CITY PLAN COMMISSION

FILE NUMBER: PLAT-25-000050 (S245-214) SENIOR PLANNER: Hema Sharma

LOCATION: Lynbrook Drive at Lorwood Drive, southeast corner

REQUEST: An application to replat a 0.289-acre (12,605-square foot) tract of land containing all of Lot 26 in City Block H/7317 to remove an existing 30-foot platted building line including wrap around along Lorwood Drive, and to extend an existing 30-foot platted building line along the east line of Lynbrook Drive to Lorwood Drive and to create one lot on property located on Lynbrook Drive at Lorwood Drive, southeast corner.

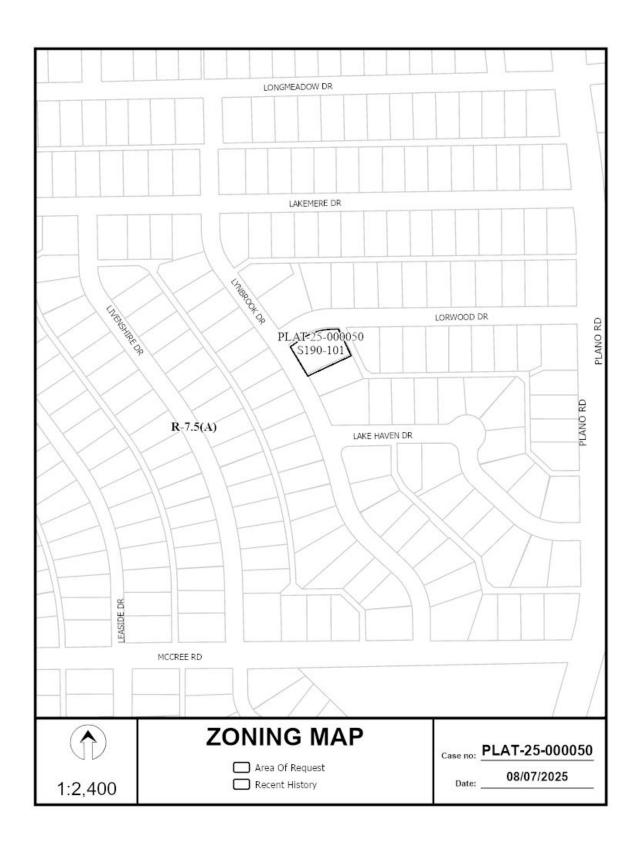
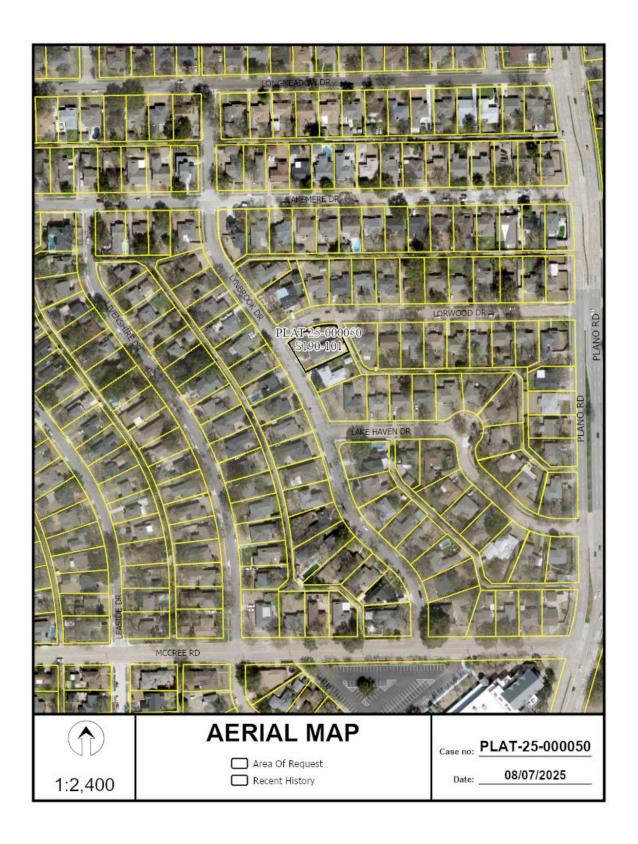
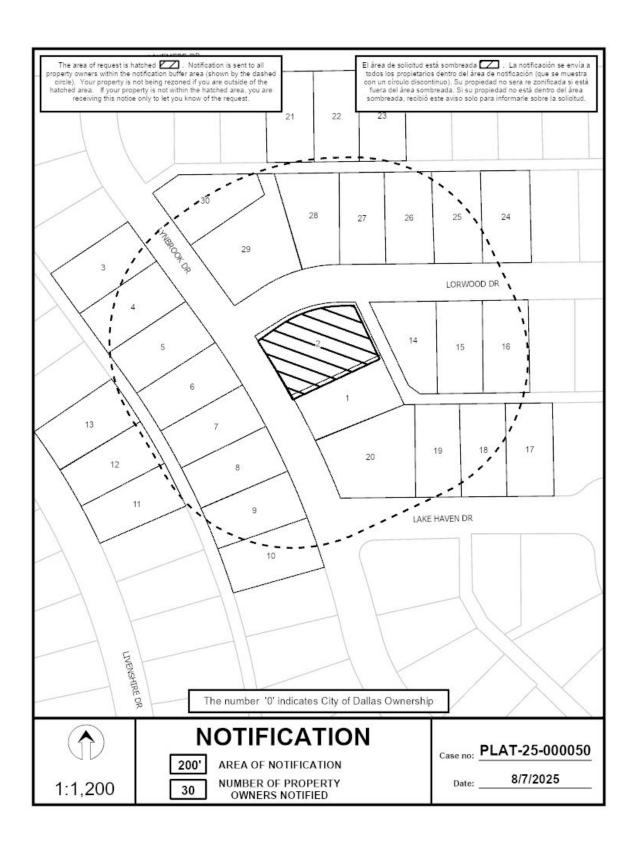
- 20. On the final plat, show the building line along Lorwood Drive as removed by this plat.
- 21. On the final plat, show the extension of the building line along Lynbrook Drive as created by this plat.
- 22. On the final plat, clarify Instrument Number 202200254757, Official Public Records, Dallas County, Texas.
- 23. On the final plat, clarify alley sight easement.
